How To Series

What Changed

Printer SKU: DCG-070-1060 L / DCG-070-1060 R

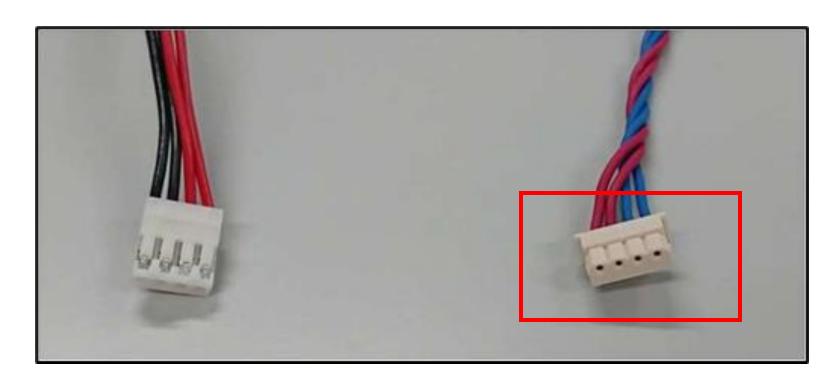
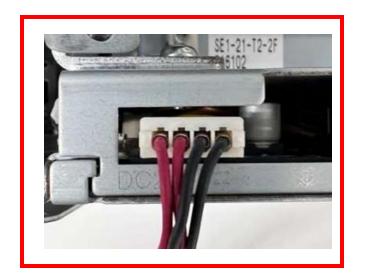
The printer power connector and printer power socket.

New Printer side: MOLEX New Power

side MOLEX

DF1B-4S-2.5R(HIROSE)

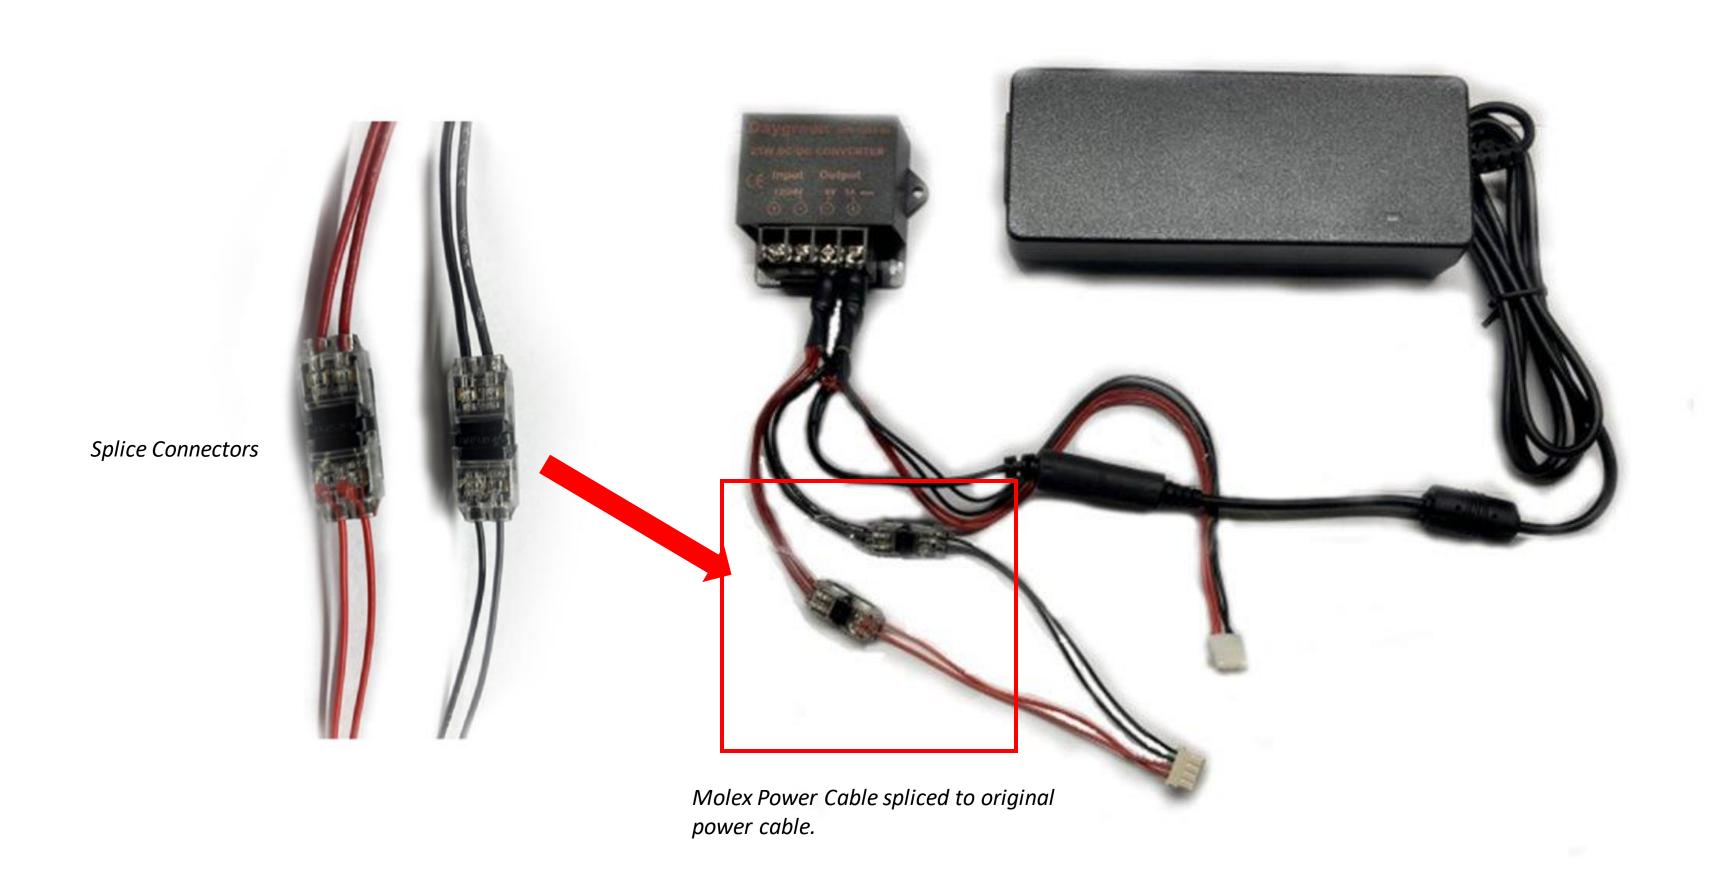
Splice Connectors are now provided with new Molex printers as an optional way to splice the included **MOLEX Cable** to the original HIROSE Cable. These splice connectors do not require the wires to be stripped. *Pictured below*.
